Sewage Treatment System (STS) Site & Soil Evaluation (SSE) Report

Property Address: 405 Meadowview Dr

Parcel ID: 45-01592

RE: Planned split at 405 Meadowview Road
PPN 4501592 (Existing Dwelling/Selected Area)
Sagamore Hills Twp., Summit County, Ohio

Site Plan 405 Meadowview Dr Parcel: 45-01592

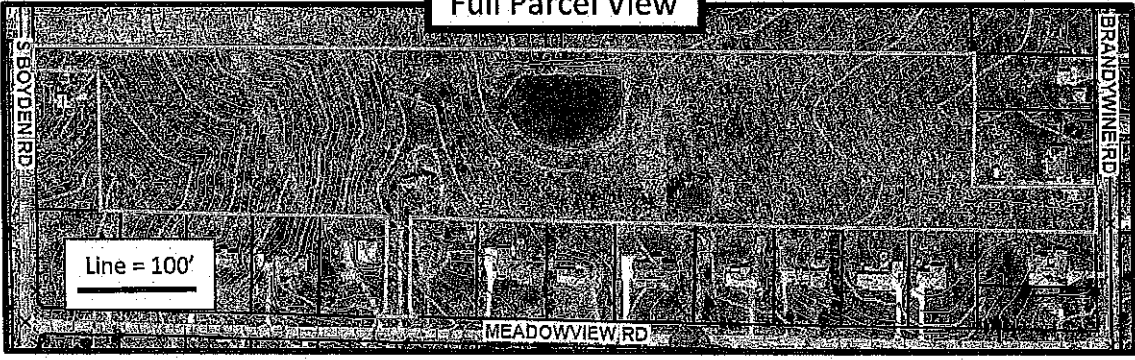
Comments: Site appears to be capable of supporting a soil-based, replacement septic system for a 3 bedroom house (360 GPD).

**Lot split pending on completion of these items:

1. Final survey of new proposed property lines

2. Replacement of the existing septic system

- Proof of OEPA's NPDES permit
- Topographic site improvement plan
- Design plan
- Other: Final Survey

405 Meadowview Road
 (Planned Split)
 PPN 4501592
 Applicant: Casey Pristou

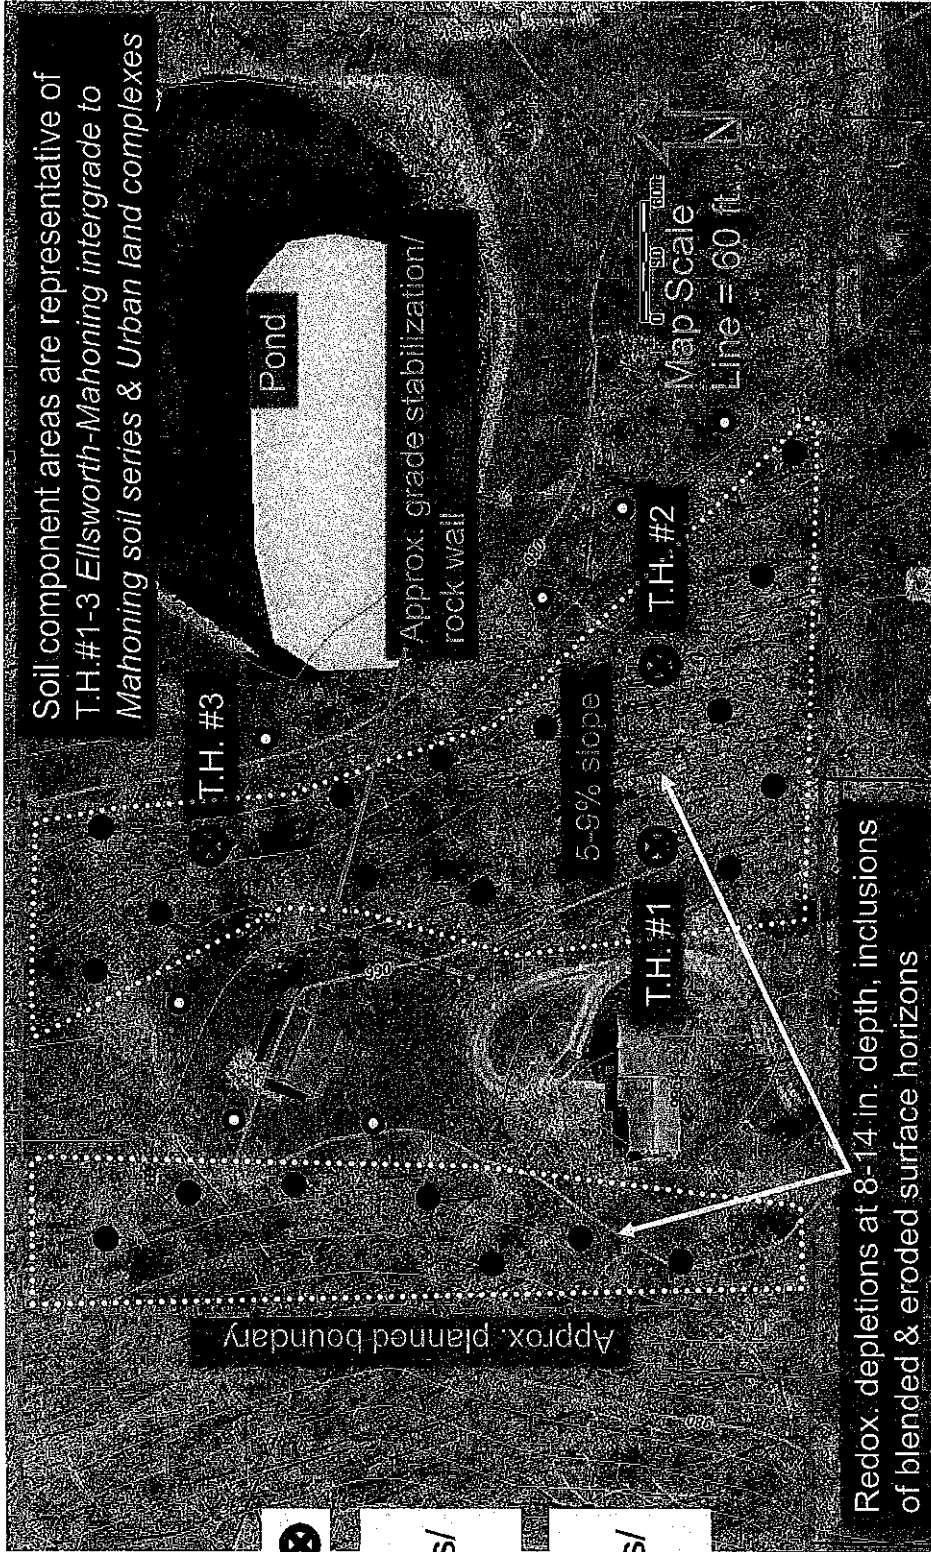
T.H.#2 is representative of T.H.#1 & 3
 soil morphology/description
 (redox. depletions at 10 in. depth)

Estimate of 178 ft. x 34 ft. (T.H.#1 & 2 at 5-9% slope),
 171 ft. x 35 ft. (T.H. #3 at 5-9% slope) needed along
 contour (4 bdrm. equiv.)
